February 27, 2026

SUBJECT: SUPPLEMENTAL RF ENGINEERING EVALUATION OF HOMELAND TOWERS APPLICATION TO INSTALL A WIRELESS TELECOMMUNICATIONS FACILITY AND MONOPOLE ON GRANITE SPRINGS ROAD IN YORKTOWN, NY

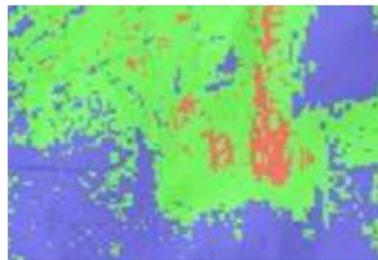
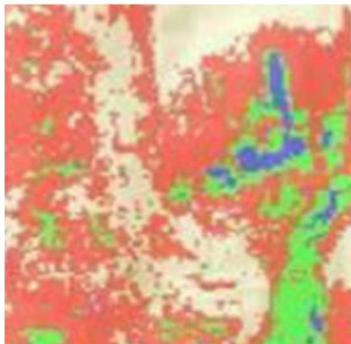
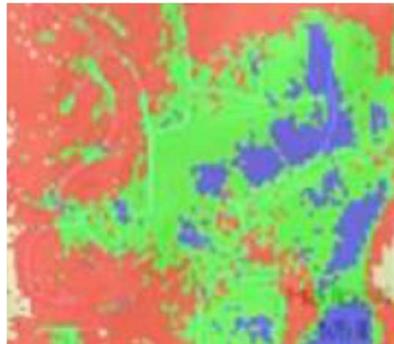
A Height Analysis section was included in the revised report in response to my request. They only evaluated lowering the tower by 20 ft, not the 10 ft requested. Comparing the 700 MHz plots and 2100 MHz plots to the proposed (130 f) monopole height, I see reduced coverage to the north and northwest, but very little difference in the other directions. The below shows the reduction in coverage to the north/northwest:

My interpretation of this analysis is that a 110 foot monopole would provide acceptable coverage at the top height (106 ft AGL), it is likely that at lower heights adequate coverage would be realized, therefore limiting the monopole to likely a single carrier (in this case, Verizon). This is not a beneficial situation for Yorktown, as it would lead to additional tower requirements.

As a result, I agree that the best height for a new monopole in this area is 130 ft AGL, which will result in the best chance of all 3 wireless carriers collocating on a single tower.
